# AP1000 TECHNICAL REPORT REVIEW

## Response to Request For Additional Information (RAI)

RAI Response Number: RAI-SRP9.1.2-SEB1-02  
Revision: 2A

RAI Response Number: RAI-TR44-009  
Revision: 2A

Figure 9.1-1 (Sheet 1 of 2)

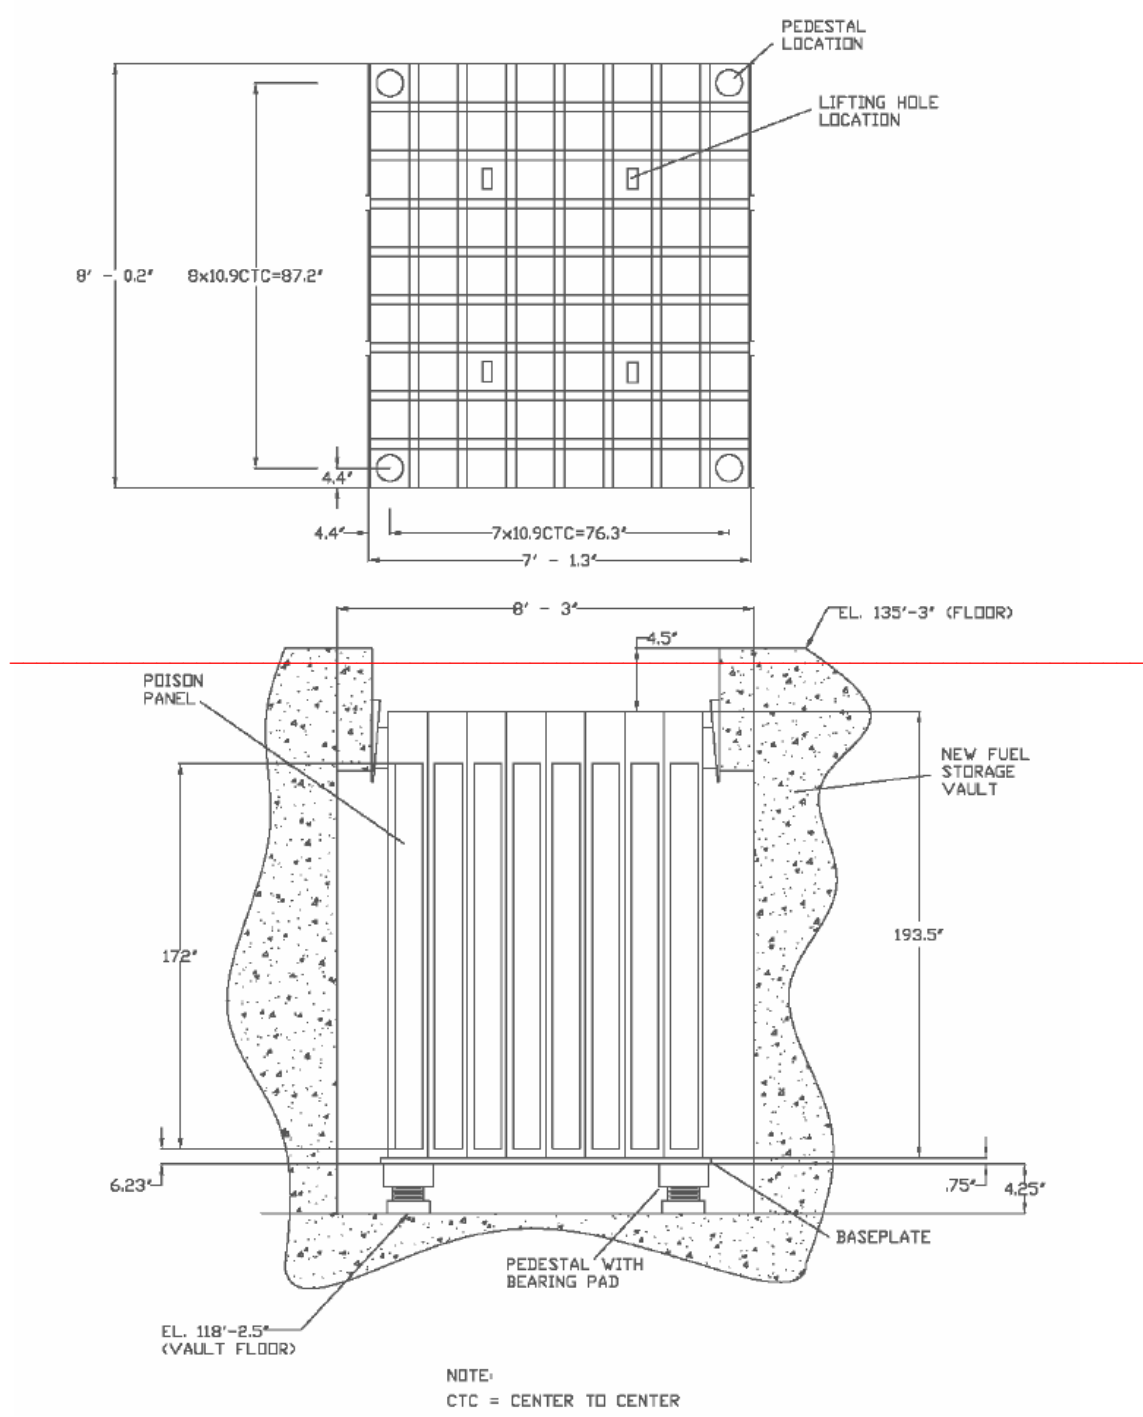
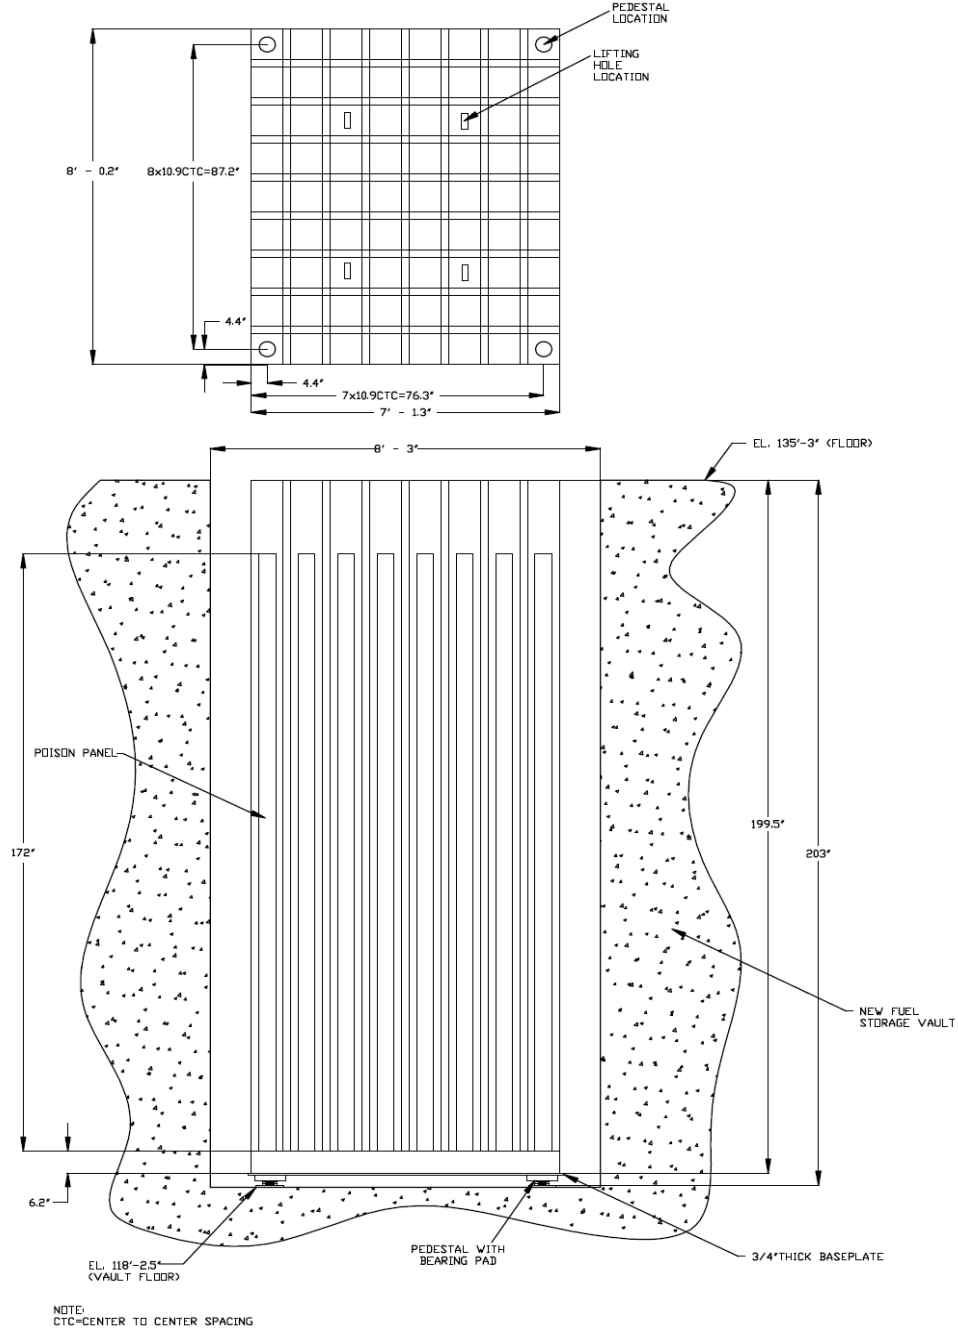
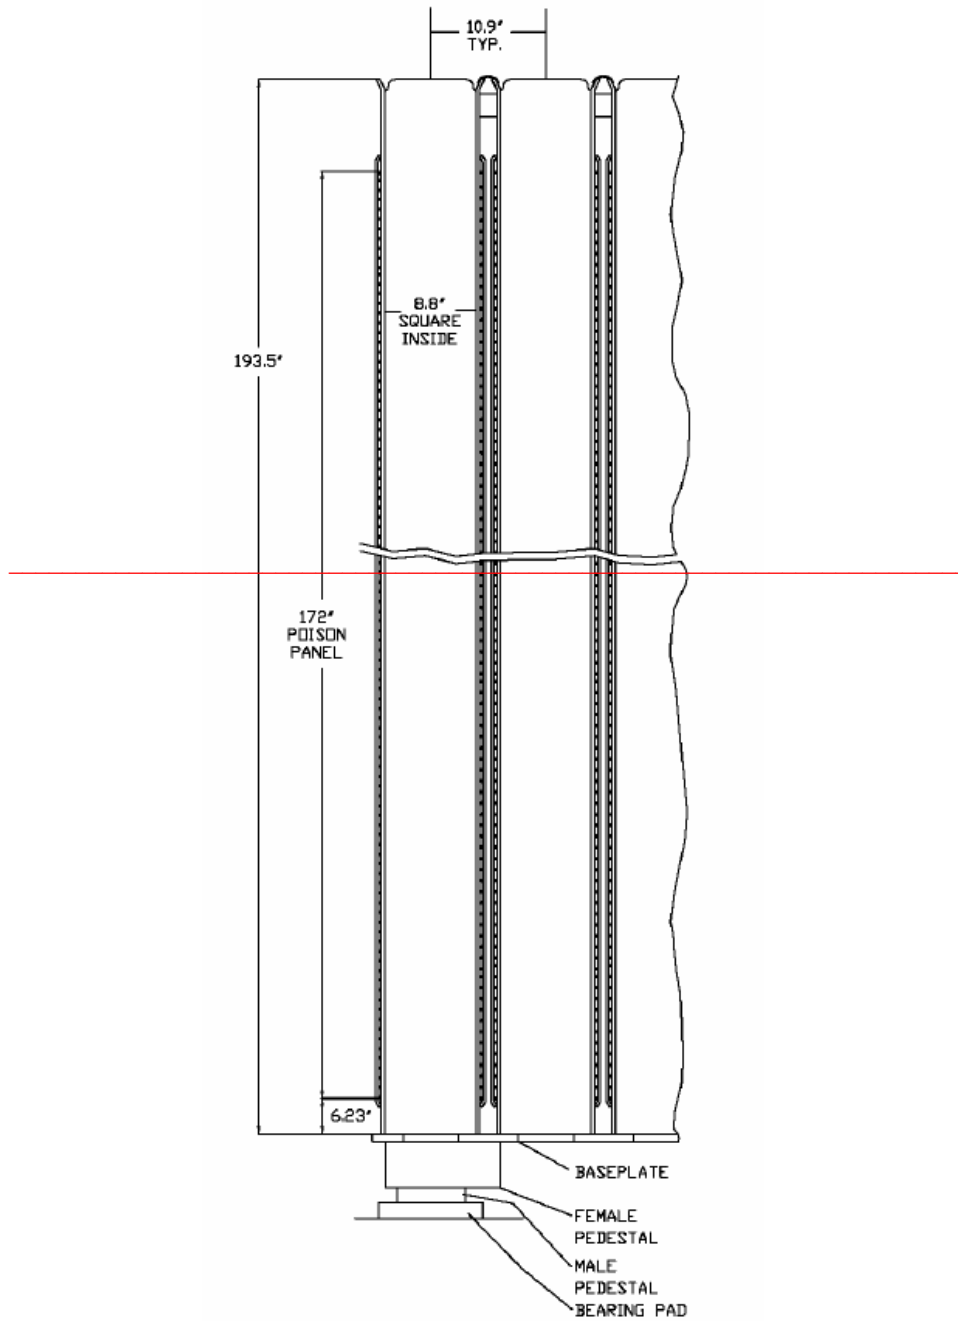
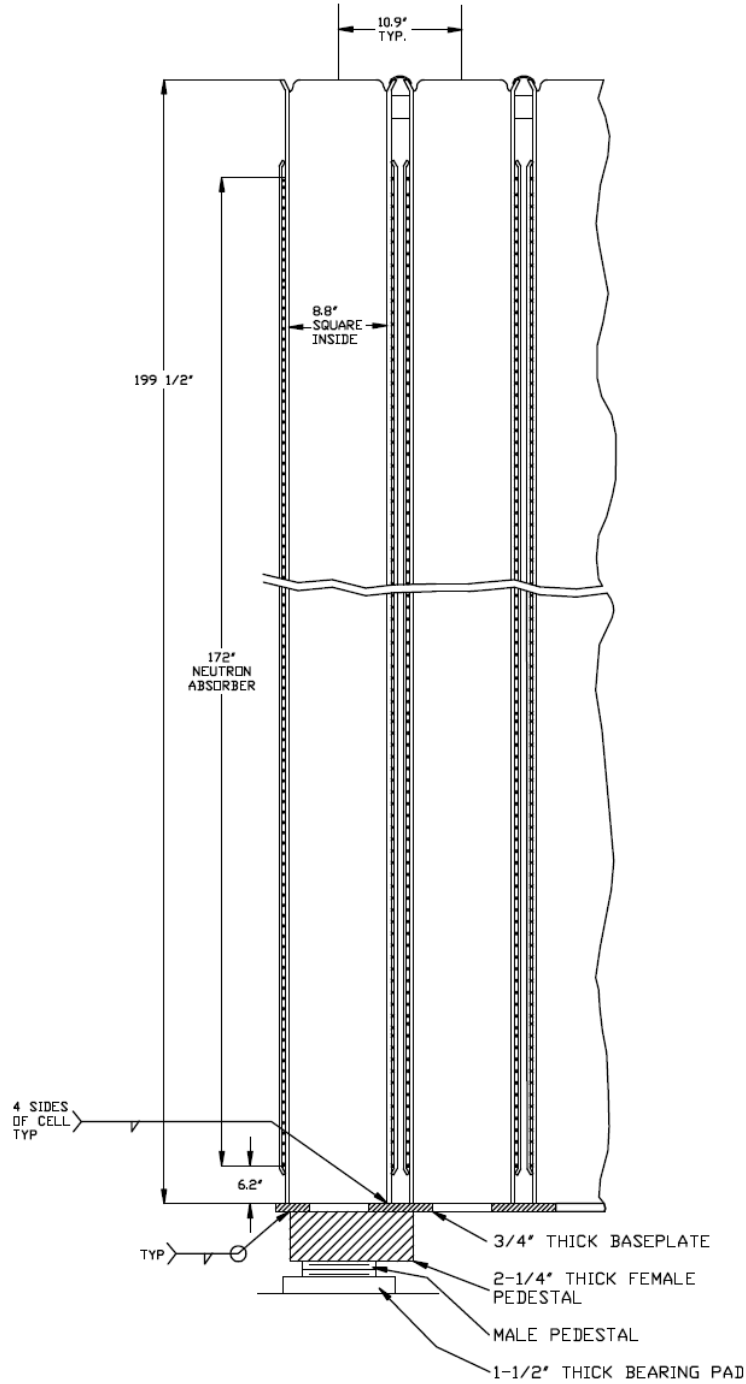
During the June 2010 audit, the NRC requested that dimension and gap information for the new fuel racks be clarified between the three similar RAIs (RAI-TR44-09, RAI-TR44-017, RAI-TR44-25) to show consistency and alignment to the current design basis shown in DCD Figure 9.1-1.

The two figures shown in the DCD and TR markup sections provide updates of the layout and cross section of the new fuel storage rack. The figures replaced Figure 2-1 of TR44 and DCD Figure 9.1-1, Sheets 1 and 2; see the DCD and TR markup sections for details.

Revise Figure 9.1-1, Sheets 1 and 2, as follows:

The change provided in the Revision 1 DCD Markup Section to Sheet 1 of Figure 9.1-1 is outdated. The most recent change to this DCD figure is included in the Revision 3 response to RAI-TR44-17. The change provided in the Revision 1 DCD Markup Section of this RAI to Sheet 2 of Figure 9.1-1 is still applicable.

**Figure 2-1 New Fuel Storage Rack Layout (72 Storage Location) (Sheet 1 of 2)**

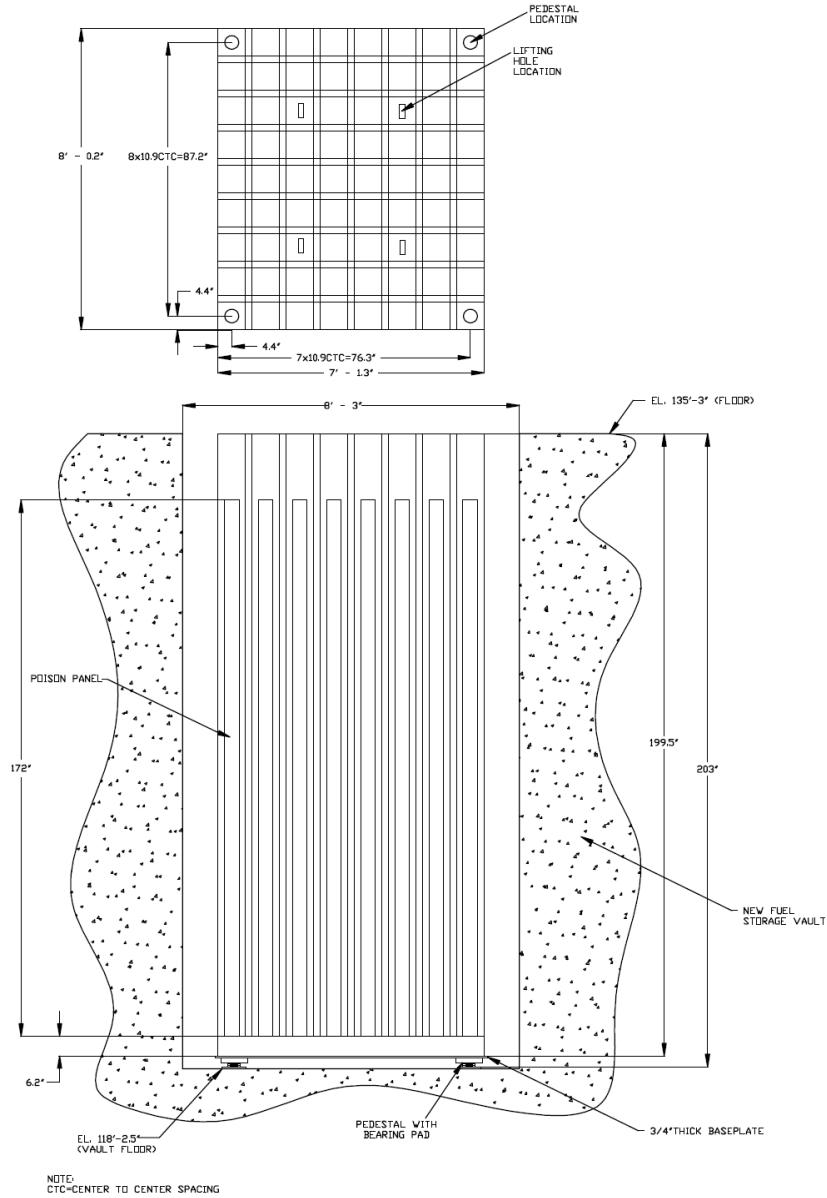
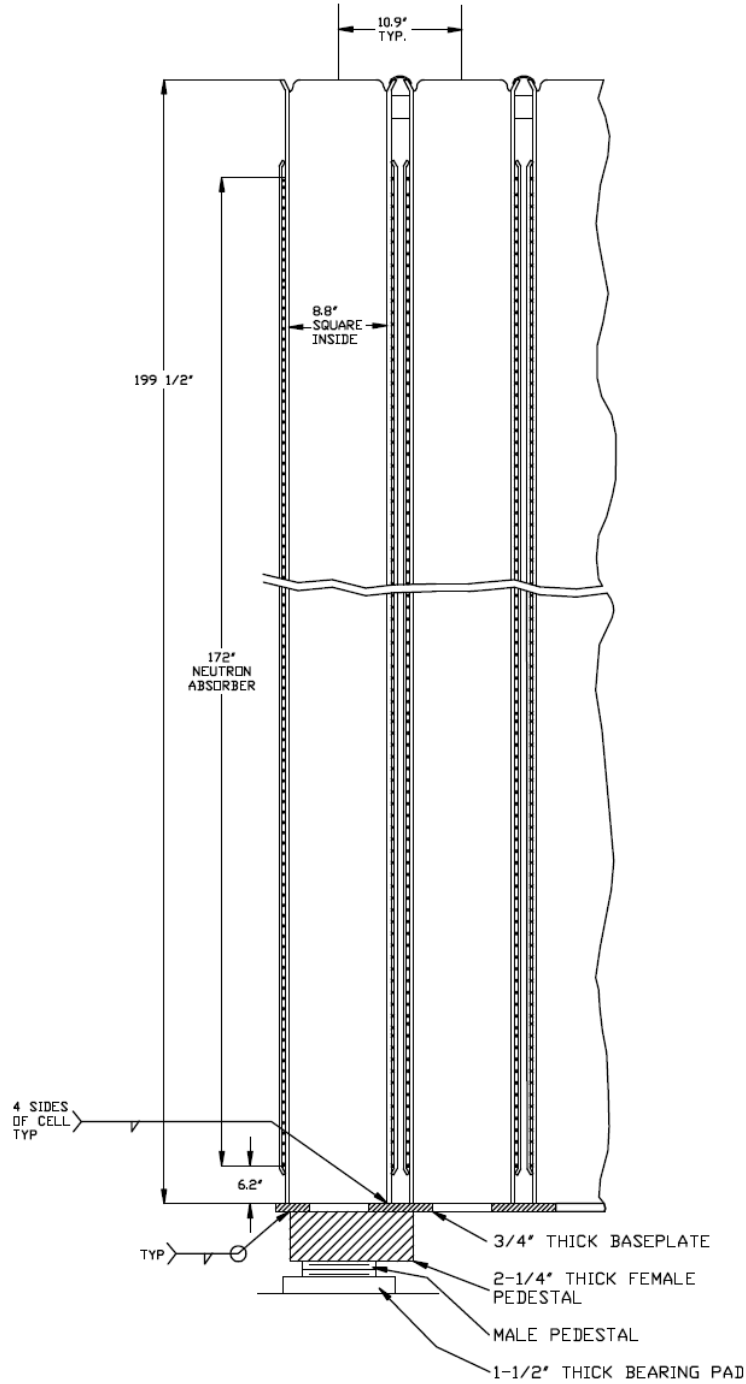
Insufficient descriptive information has been included in the new fuel report to permit an adequate review of the structural/seismic analysis of the new fuel rack. Please provide descriptive information including plans and sections showing the new fuel rack and vault walls. All of the major features of the rack including the cell walls, baseplate, pedestals, bearing pads, neutron absorber sheathing, any impact bars, welds connecting these parts, and any other elements in the load path of the rack should be shown on one or several sketches. These sketches should also indicate related information which includes key: cutouts, dimensions, material thicknesses, and gaps (fuel to cell, rack to walls). In addition to the above, for review of postulated fuel handling drop accident and quantification of the drop parameters, sketches with sufficient details for the fuel handling system should be provided.

Figure 2-1 was renamed and replaced by the following 2-sheet figure:

The equivalent new fuel rack layout figures (Sheets 1 and 2 of Figure 2-1) currently shown in the latest revision of TR44 (Reference 1) are correct.

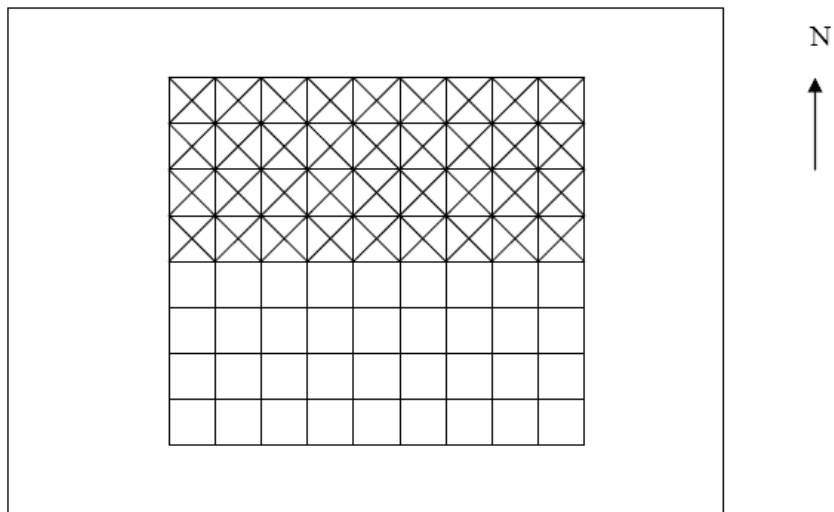
Explain whether only a full fuel rack is considered in the simulation, or if several scenarios are considered; i. e., different fill ratios, from empty to full. Provide the technical justification if only a full rack is considered.

After NRC reviewed the supplemental RAI response from the August 2009 audit, they requested that the RAI response be revised to delete the argument that the partial loading case is not controlling.

Following the August 2009 audit with the NRC, Westinghouse has completed an additional run (Run Number 4) to examine the effects of the worst possible partial rack loading scenario (half full, all on one side, as depicted in the following figure). The results of this additional run will be included in Revision 2 of TR-44. Also, DCD Section 9.1.1.2.1, Item A, is modified to indicate that a partially filled loading case was evaluated.

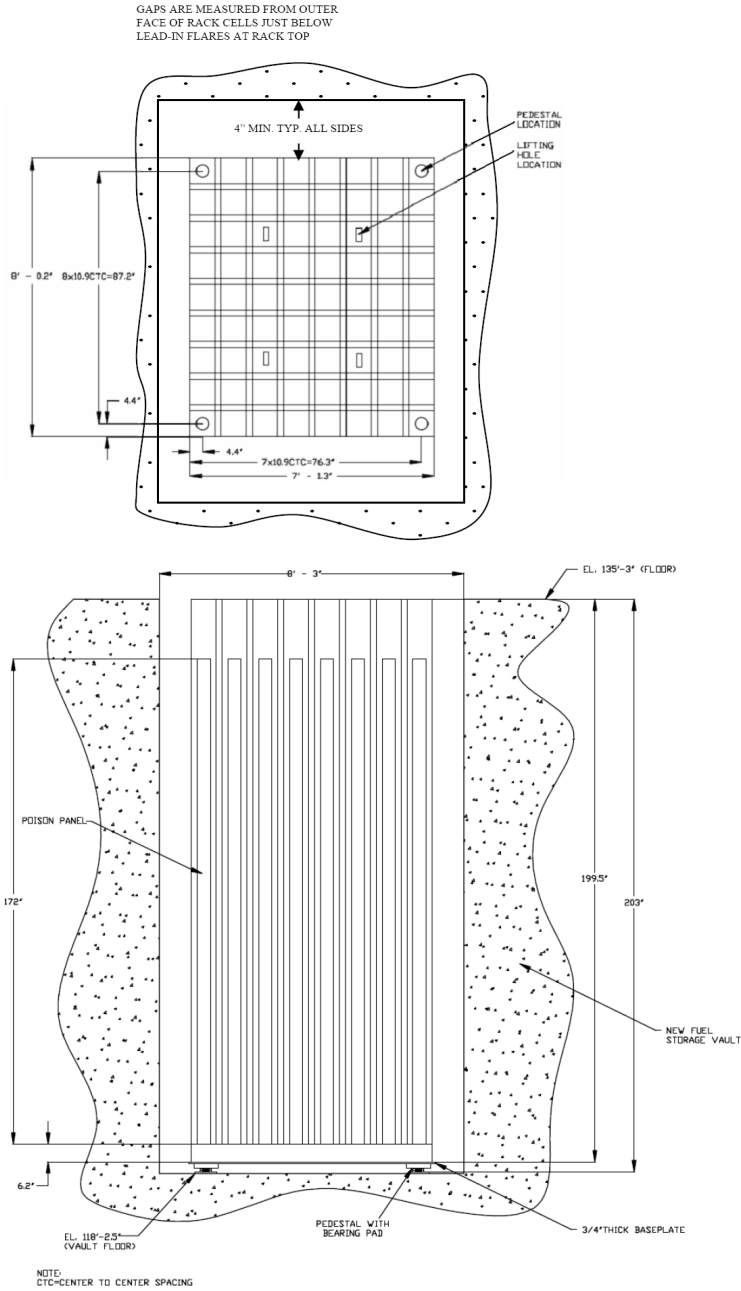
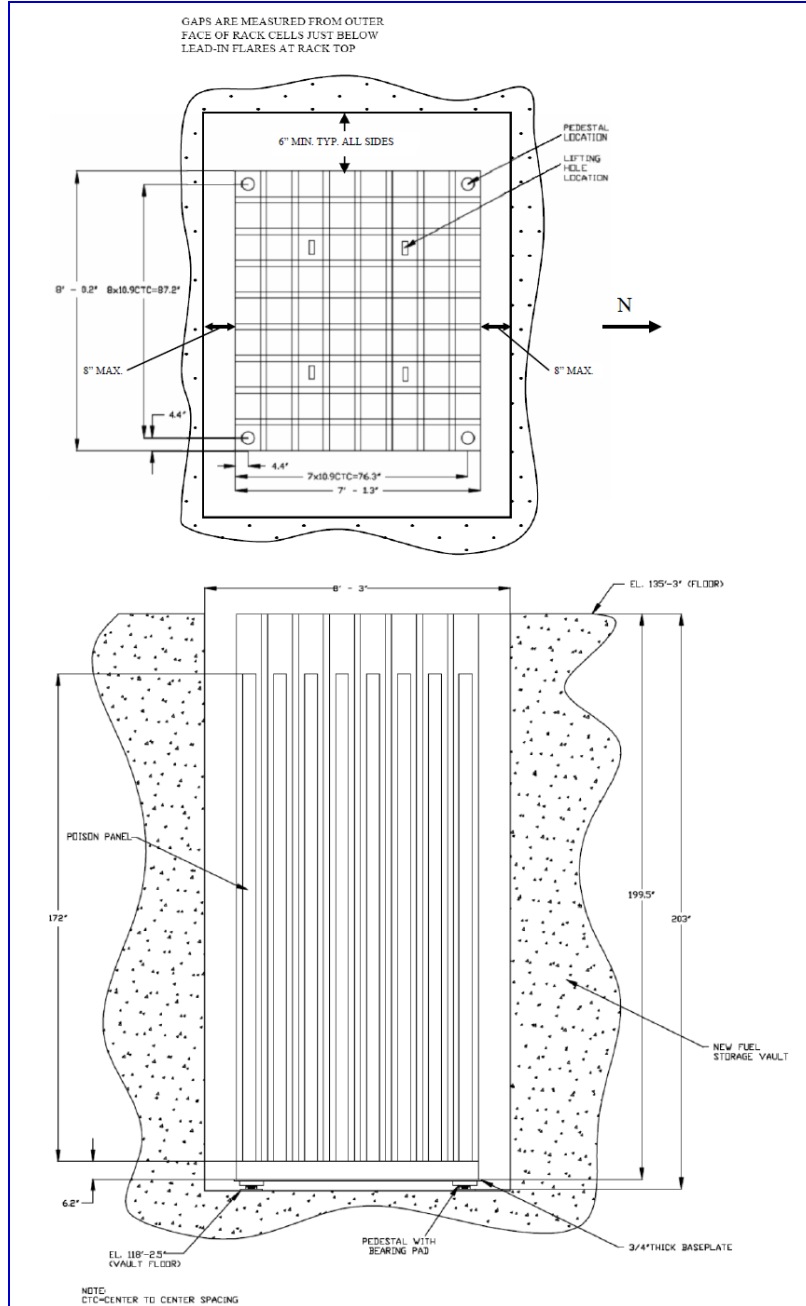
What are the gaps and tolerances for each of the gaps between the fuel assembly and cell wall, and between the rack and vault wall? What are the assumed initial locations of the various components (fuel assemblies and rack) and what is the technical basis for this assumption. Were any studies done for different initial conditions (considering tolerances); if not, explain why it was not necessary. Are there requirements in the DCD to ensure that the assumed gaps (considering tolerances) are maintained throughout the operating license period?

During the June 2010 audit, the NRC requested that dimension and gap information for the new fuel racks be clarified between the three similar RAIs (RAI-TR44-09, RAI-TR44-017, RAI-TR44-25) to show consistency and alignment to the current design basis shown in DCD Figure 9.1-1.

Following the August 2009 audit, Westinghouse is updating DCD Figure 9.1-1 to include additional details related to the placement of the New Fuel Storage Rack within the New Fuel Pit. Figure 9.1-1 will be updated as shown in the DCD Revision section below to show the general position of the rack within the pit, including a definition of the minimum gaps. The only changes to the figure are that the rack is now shown within the vault and the 4 inch minimum typical gap dimension along with the clarifying note about where the gaps are measured from have been added. The 4 inch minimum gap is conservative based on the maximum rack displacement of 3.2 inches (which occurs at the top of the rack; the maximum displacement at the baseplate elevation is only 0.5 inches) when the 0.2 COF is ignored (justification for ignoring the 0.2 COF case is discussed in the response to RAI-SRP9.1.2-SEB1-02, Revision 1).

Replace DCD Figure 9.1-1 with the following figure:

The DCD Change proposed by RAI Revision 2 above is no longer current. The following change to DCD Figure 9.1-1 (Sheet 1 of 2) represents the current design basis in TR44. The DCD Figure 9.1-1 (Sheet 2 of 2) is not modified by any revision of this RAI response.
